SANITARY SEWER RELOCATION TO SERVE

TYLER ACRES FIFTH ADDITION
HOLLYWOOD ENTERTAINMENT

574 PPS (607861)

Private Sanitary Sewer To Serve
Hollywood
Entertainment - Part of Tyler Acres Fifth Addition

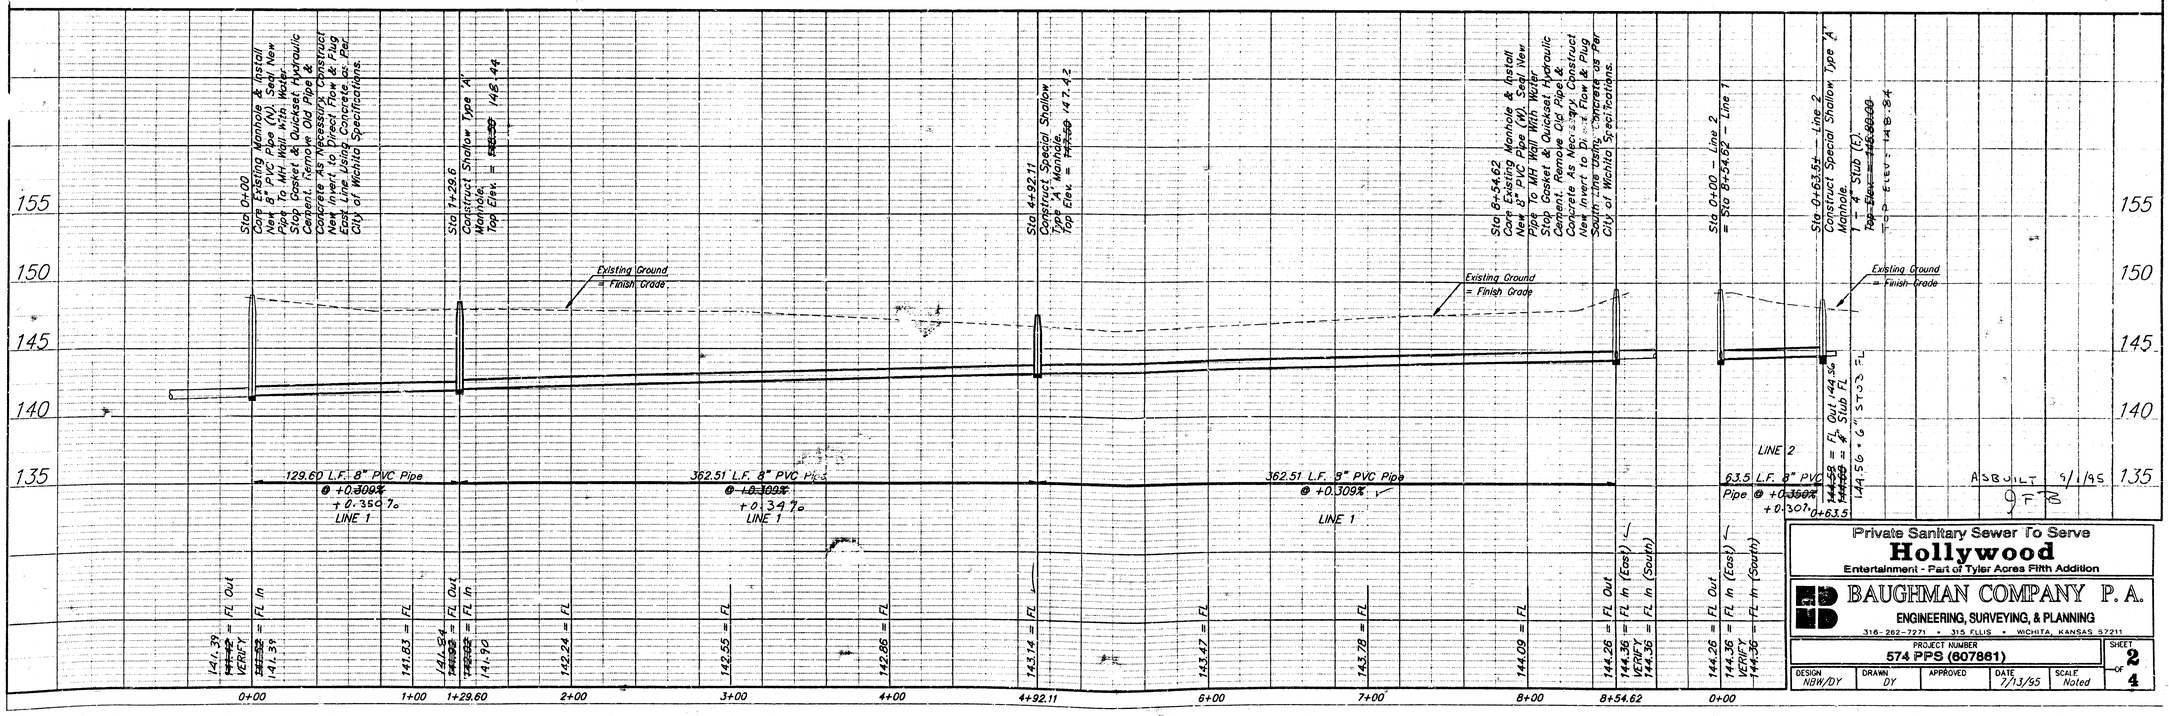
Sta 1+29.6 – Line 1
Construct Shallow Type 'A' Manhole.
Top Elev. = ~~145.50~~ 146.44

SS Manhole
Rim = ~~149.54~~ 149.52
℄ = 144.36(In)
℄ = 144.23(Out)

Sta 4+92.11 – Line 1
Construct Special Shallow Type 'A' Manhole.
Top Elev. = ~~147.50~~ 147.42

Sta 0+63.5± – Line 2
Construct Special Shallow Type 'A' M.H.
Top Elev. = ~~148.84~~ 1 – 4" Stub (E) 6"
VERIFY ℄ cation Of Exist. Service Connec.ion For Location of MH & Stub. Contractor Shall Be Responsible For Reconnection Of Service Line. All Costs For Replacement Of, or Regrading Of Service Line, and Removal and Replacement of Asphalt Necessary for Reconnection of Existing Service Line Shall Be Incidental to Other Project Costs.
